Change Notification #: 113194 - 00
Change Title: Intel® Server System R2208GZ4GS9
PCN 113194-00, Product Design
Update Resistors and Capacitors and the 750W
Common Redundant Power Supply
FXX750PCRPS Firmware
Date of Publication: August 06, 2014

Intel is implementing the following changes on the Intel® Server System R2208GZ4GS9:

Figure 1. Component Locations for the 2U Riser Spare A2UL8RISER

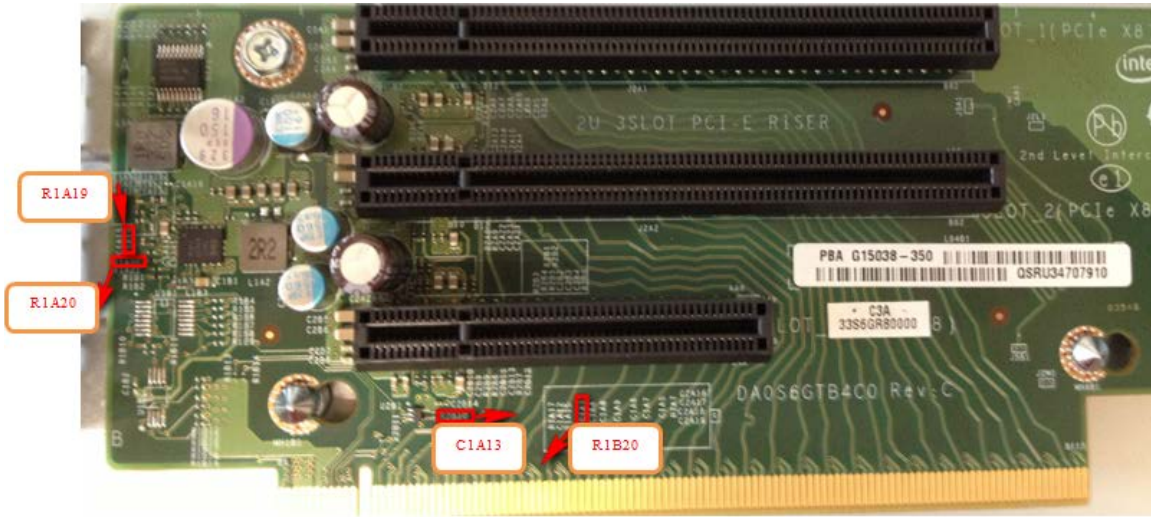
1. Update the following resistors and capacitor (see Table 1 and Figure 1) on the 2U PCIe Riser Spare A2UL8RISER to make an improvement to support a higher 3.3 Voltage Regulator startup over current. Before this change, the Voltage Regulator on the riser card may not be able to turn on when the total current drawn is more than 5A current. After this change, the Voltage Regulator on the riser card can support more than 10A current.

Component	Location	Pre-change	Post-change
Resistor	R2B10	10.0 kOhm	3.65 kOhm
Resistor	R1A20	0 Ohm	30 Ohm
Resistor	R1A19	40.2 kOhm	20 kOhm
Capacitor	C1A13	10 pF	120 pF
